ADDENDUM NO. 2

**MSHP Interoperability Site,
Replace Roof & Renovate Basement and Access,
Support Services Bldg.,
2413 East McCarty St.,
Jefferson City, MO 65101
PROJECT NO. R2508-01**

Bidders are hereby informed that the Construction Plans and/or Specifications are modified as follows:

- ROOF SYMBOLS**
- PARAPET WALL
 - ROOF DRAIN W/ SUMP
 - ROOF SLOPE
 - OVERFLOW SCUPPER
 - SCUPPER W/ COLLECTION BOX (DOWNSPOUT)
 - PIPE PENETRATION
 - +5.25 APPROXIMATE INSULATION THICKNESS

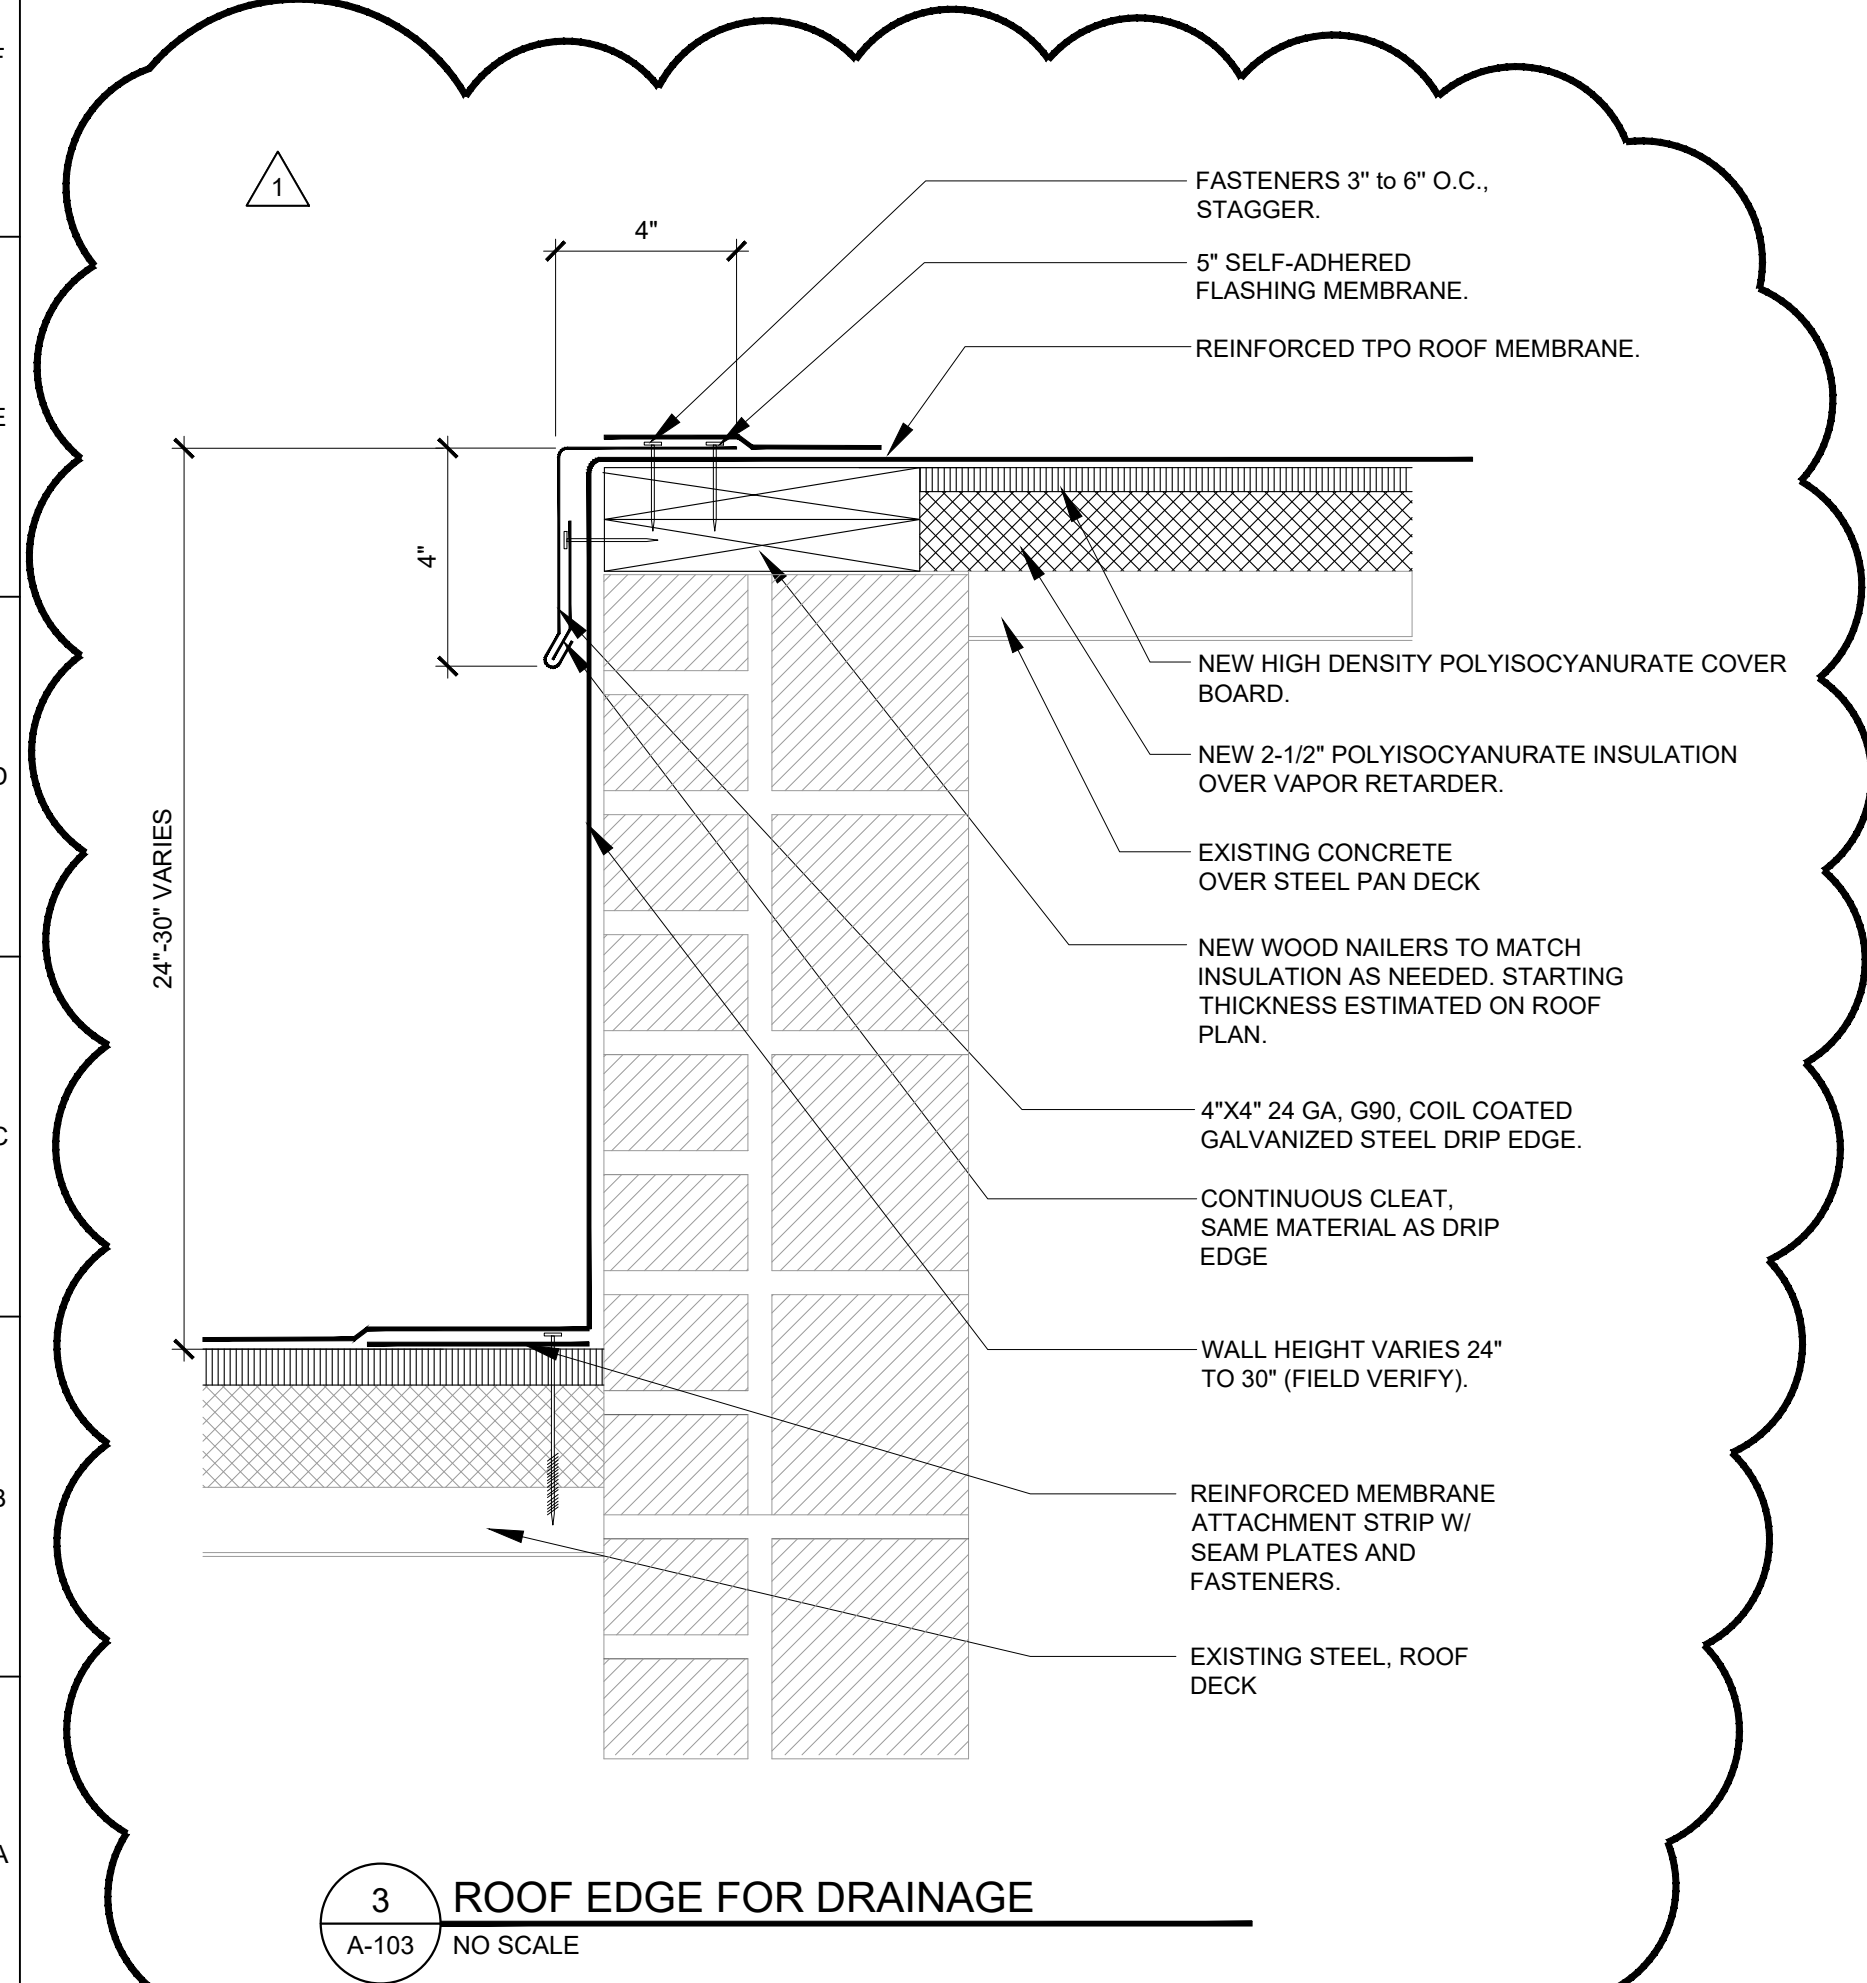
4. *SHEET D102*

- a. ADD Demo existing down spout. Trench to new location. See A102. This occurs on Southeast and Southwest corners.

SHEET TITLE:
ROOF PLAN AND
ROOFING DETAILS

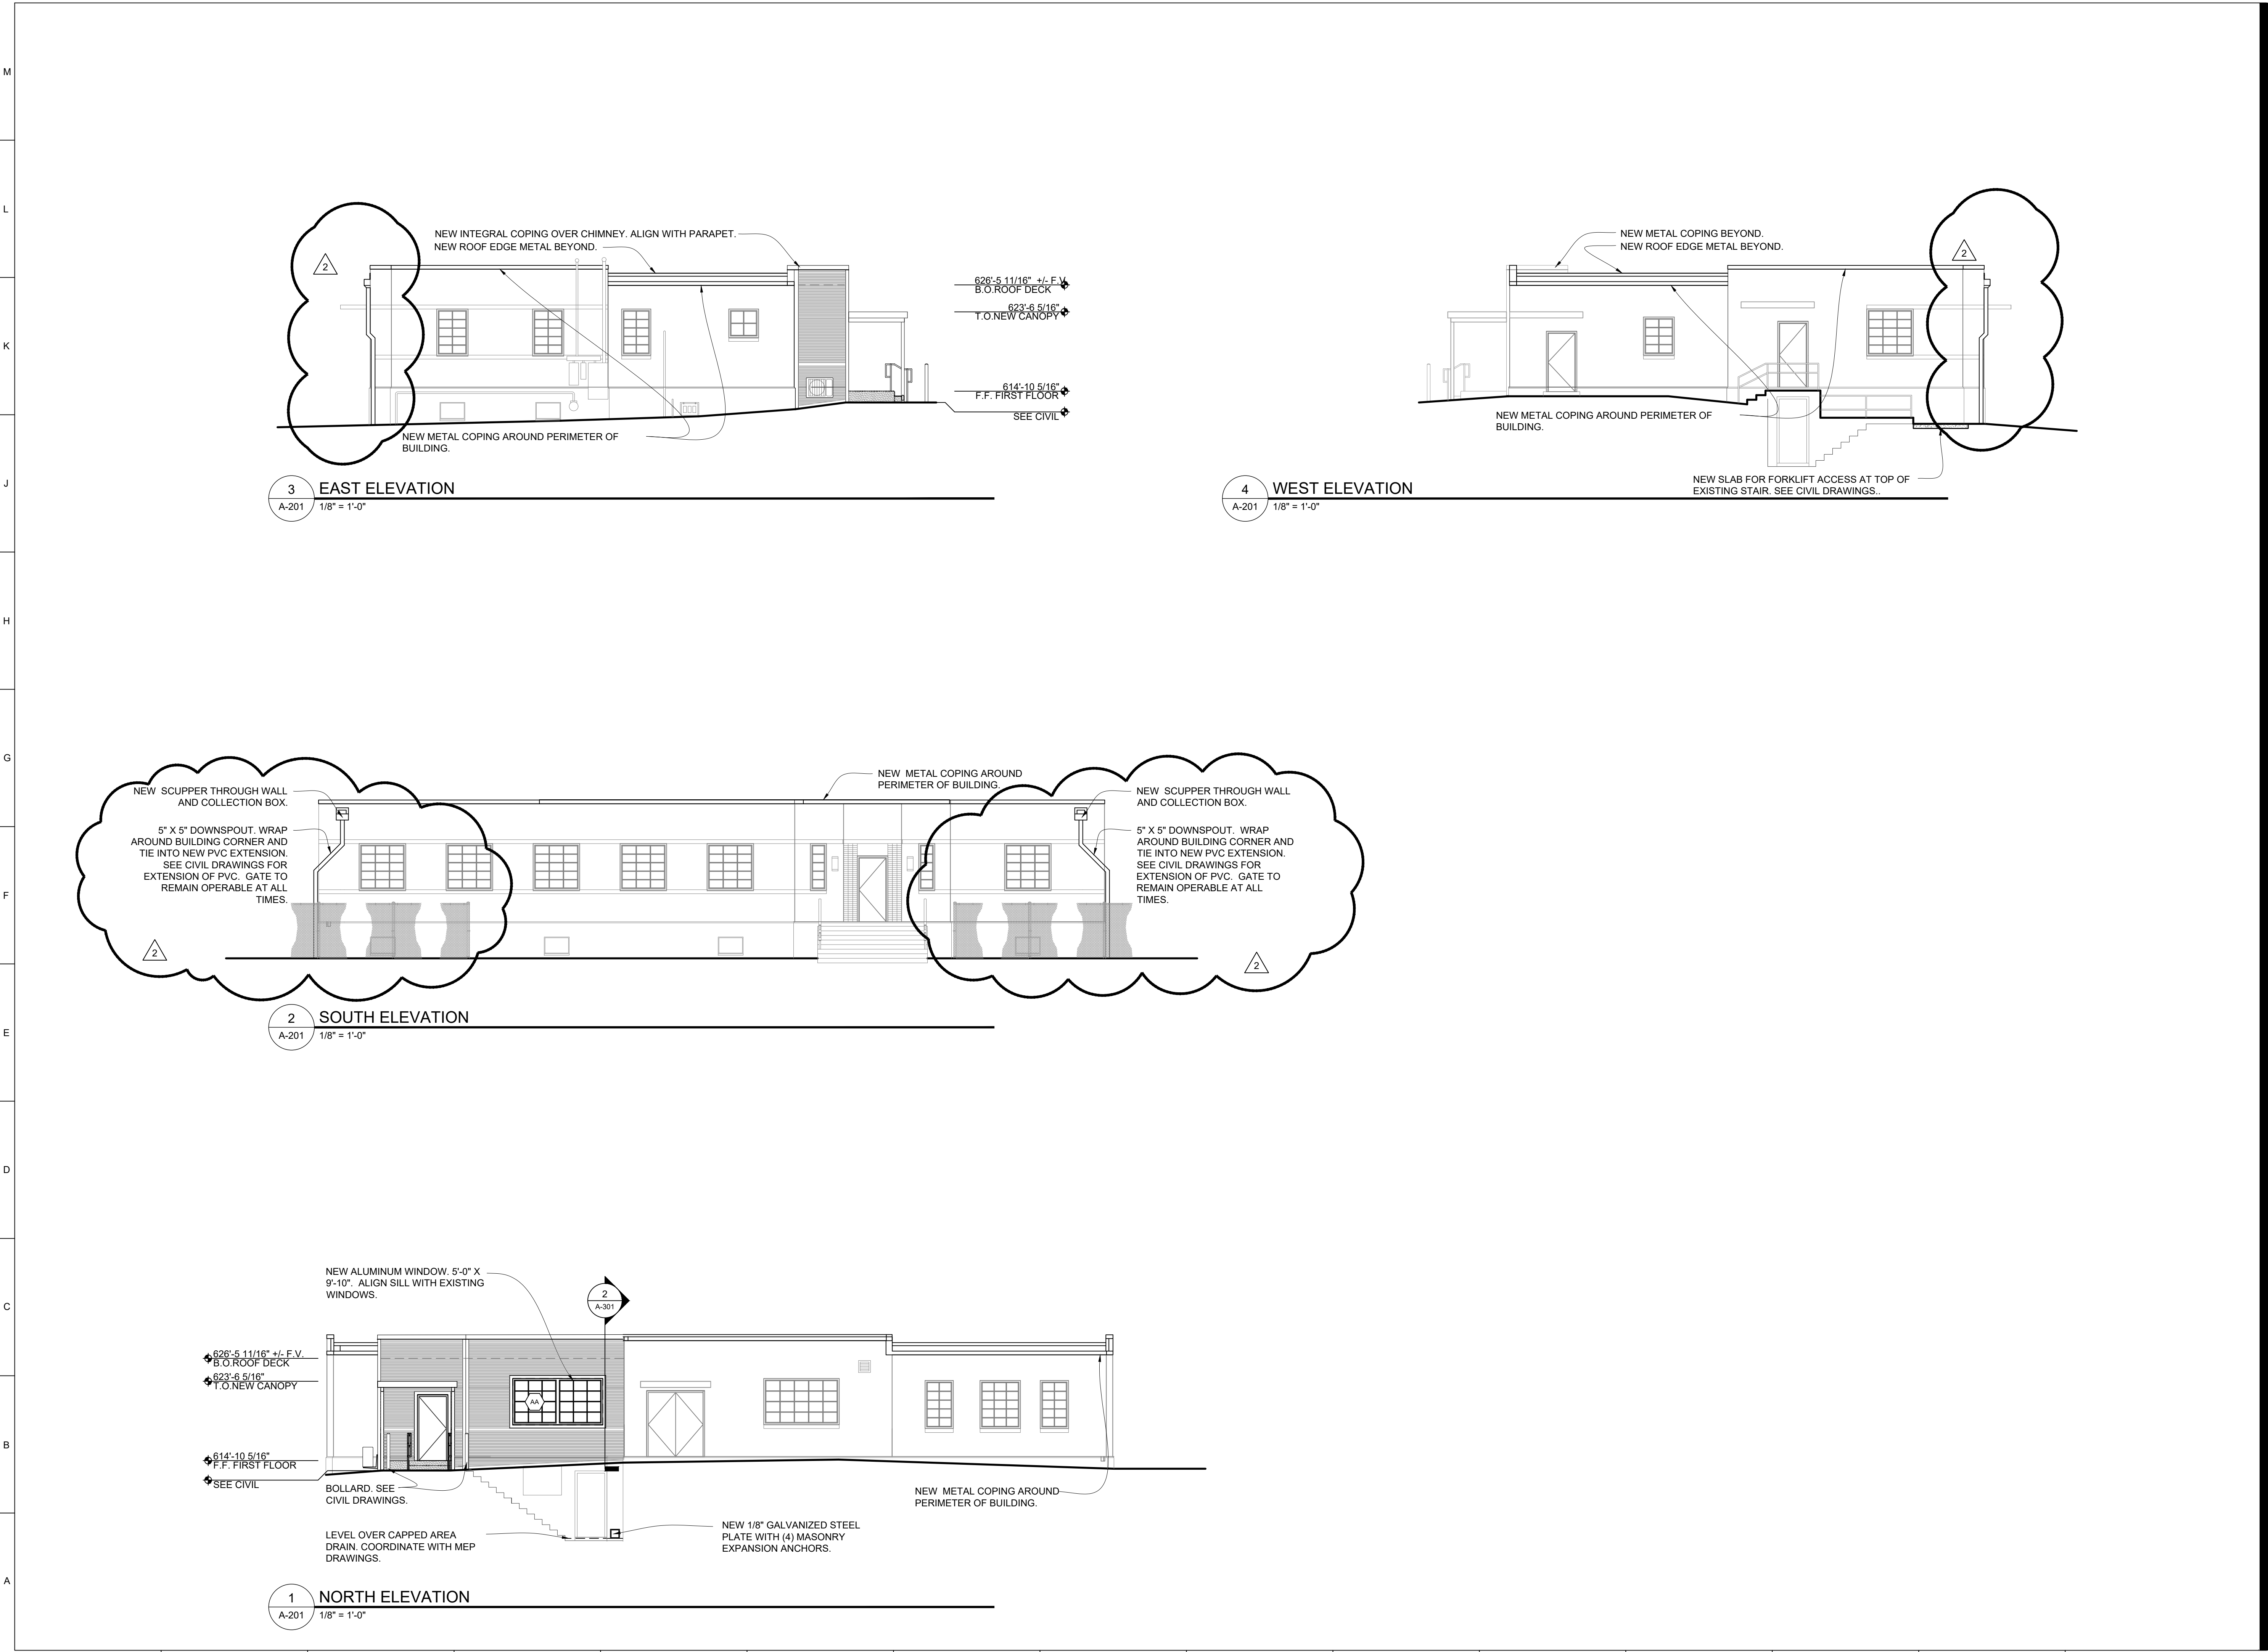
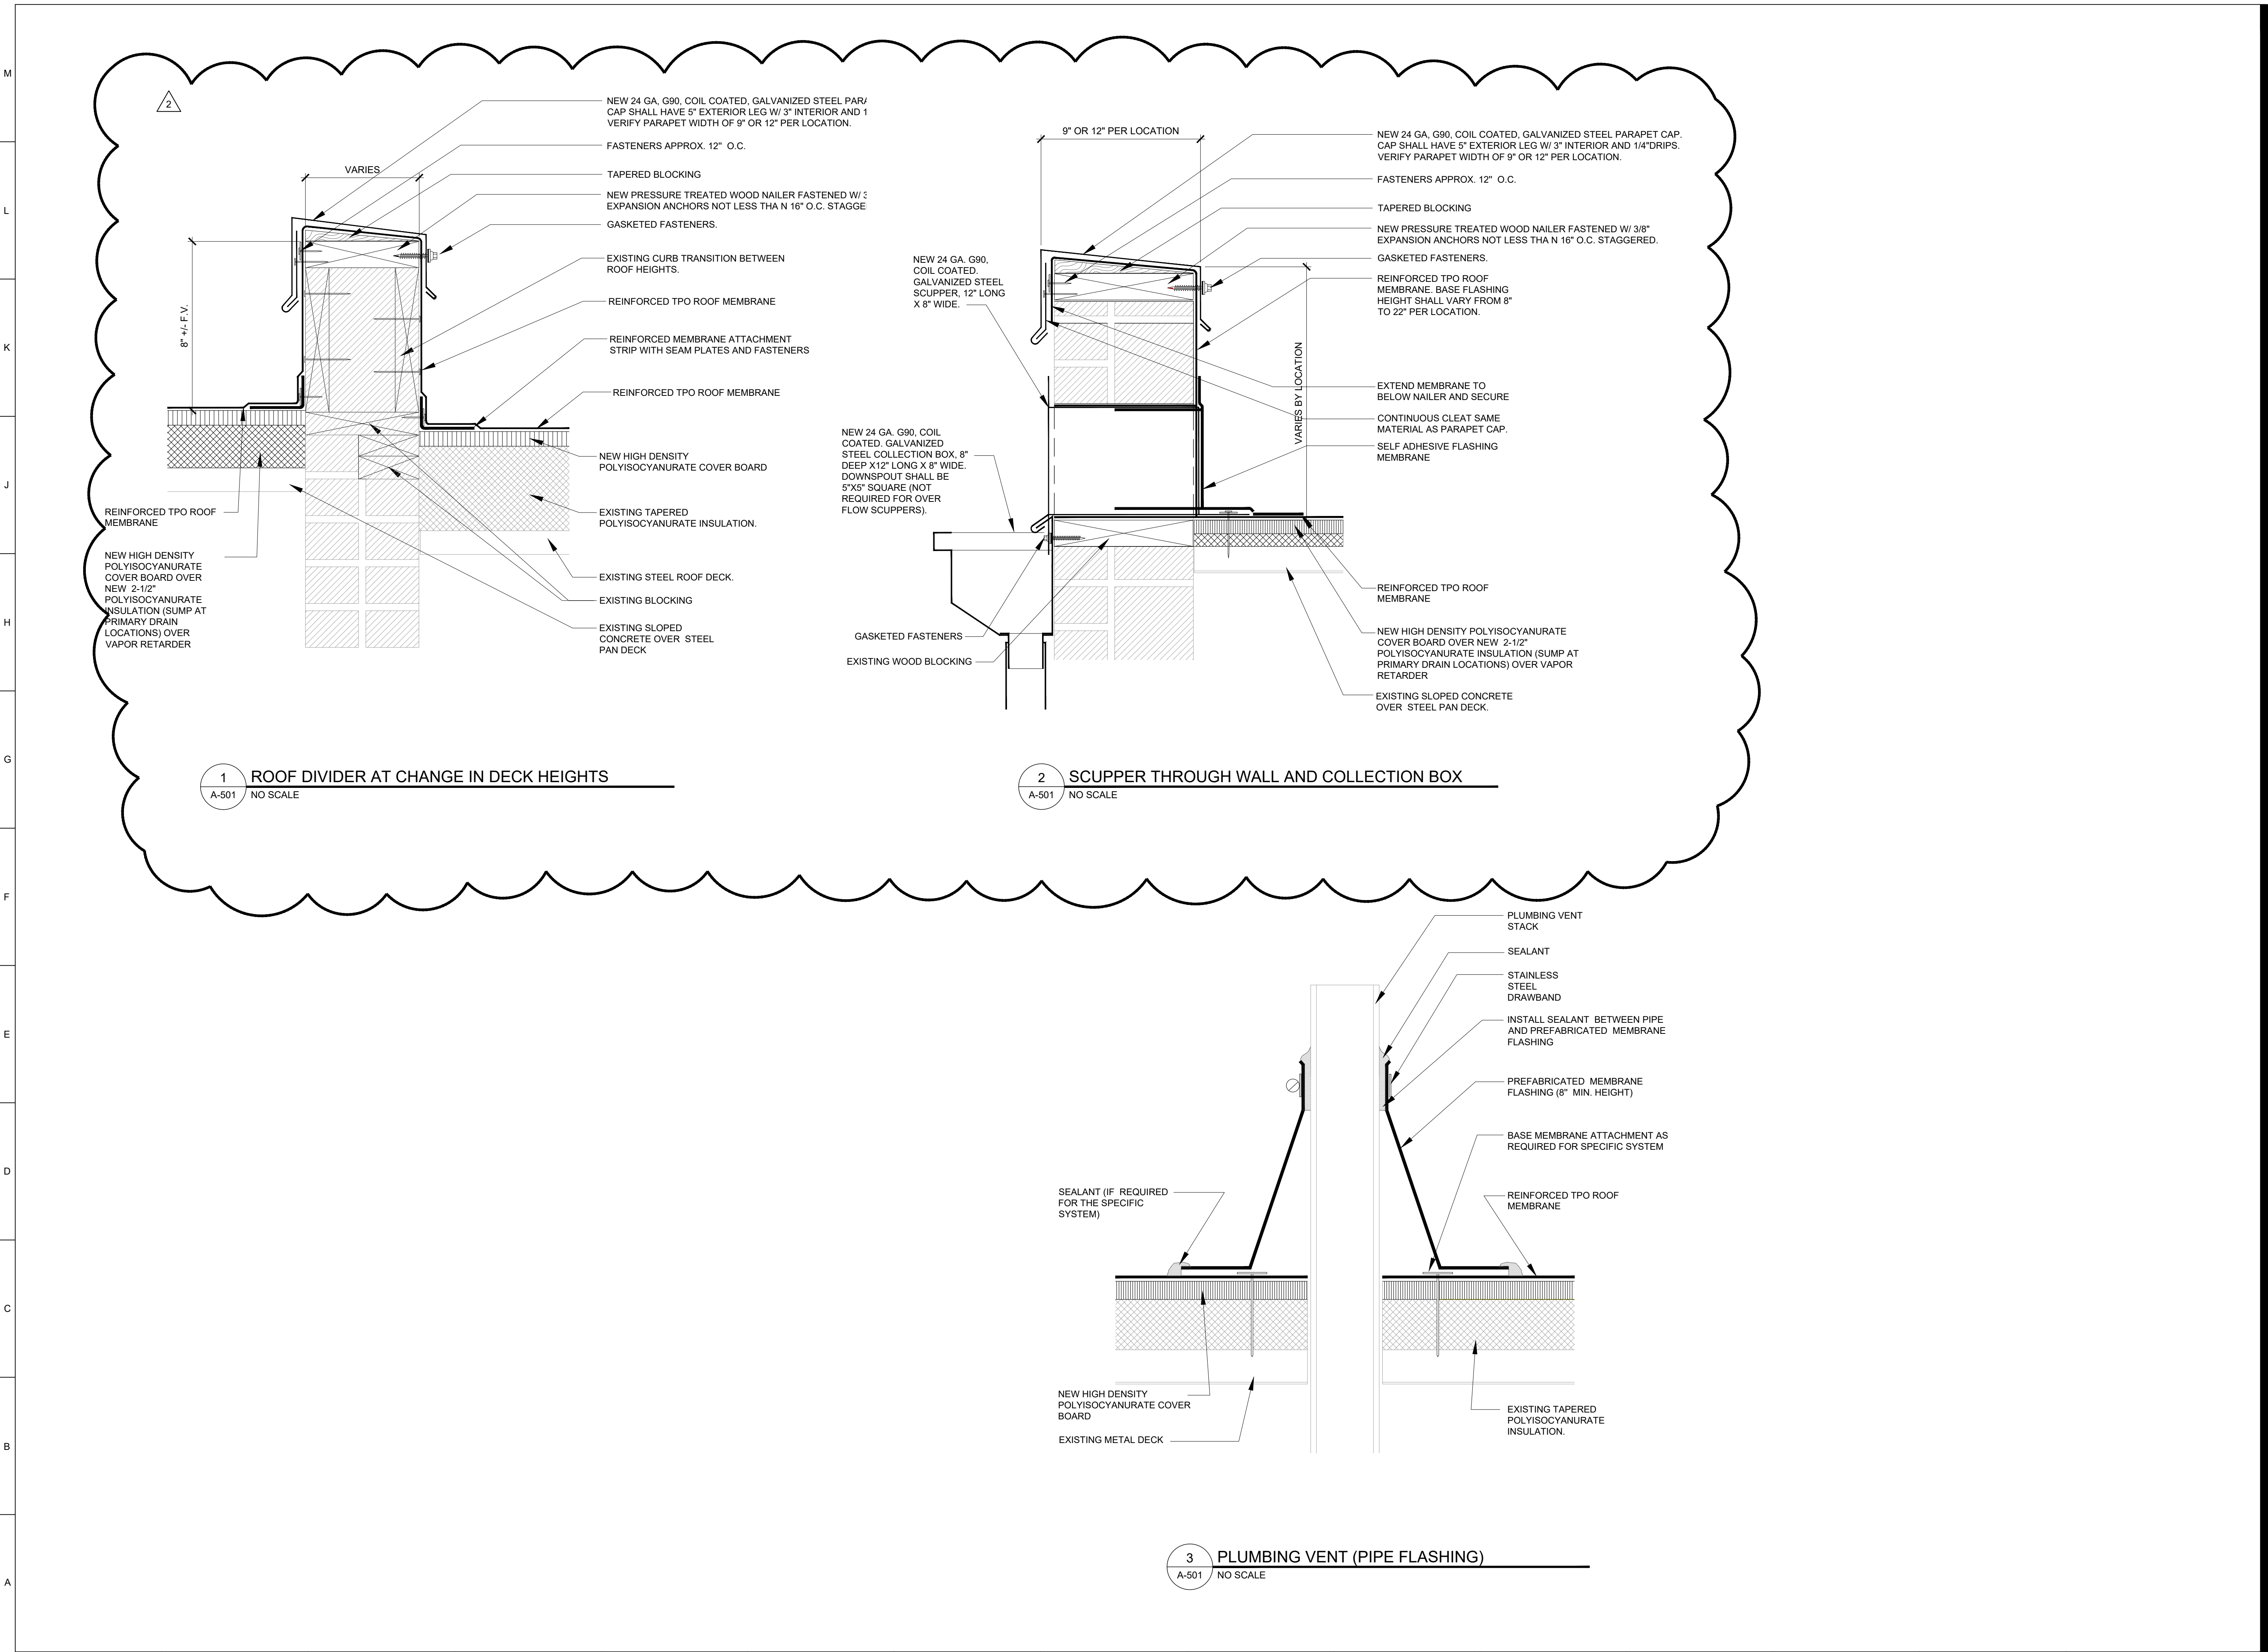
6. *SHEET A103*

- a. REVISE Demolition notes: Roof
- b. REVISE Downspout leader. This occurs on Southeast and Southwest corners.
